UNITED STATES PATENT AND TRADEMARK OFFICE

Office Action Summary	Application No. 10/520,092	Applicant(s) MARTIN, PETER JOSEF	
	Examiner GLORIA R. WEEKS	Art Unit 3721

DETAILED ACTION

Figure 1 of Niske

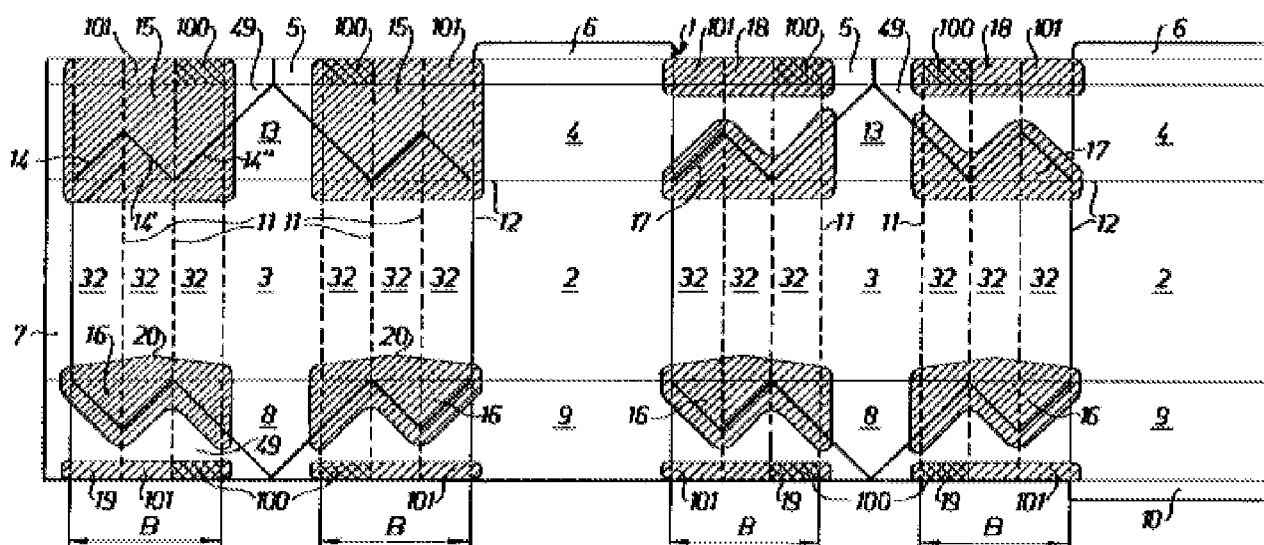
In reference to claim 19, 20, 22, 24-26, 28-30, Niske discloses a packaging material that is folded into a packaging and subsequently filled(column 1 lines 5-14 and 61-65), the packaging material comprising: longitudinal and transverse 12 fold lines; and stamped straight line markings 11, 14, 14', 14'' having intersecting paths, the markings 11, 14, 14', 14'' comprising a parallelogram (32 x1) within a first rectangular frame (32 x2) that has sides that are parallel to the longitudinal fold lines, and the first rectangular frame within a second rectangular frame (32 x3), such that a corner of the parallelogram (32 x1) bisects¹ a side of the second rectangular frame (32 x3);wherein the markings 11, 14, 14', 14'' have a "U-shaped" cross-section. Page 5,

lines 26-37 of Applicant's specification defines the phrase "U-shaped cross-section" as a configuration that projects into or out of a respective surface. Column 5 lines 21-27 of Niske disclose the markings 11, 14, 14', 14'' as indentations, thereby meeting Applicant's limitation of markings having a "U-shaped cross-section.

Illustration of fold lines disclosed by Niske
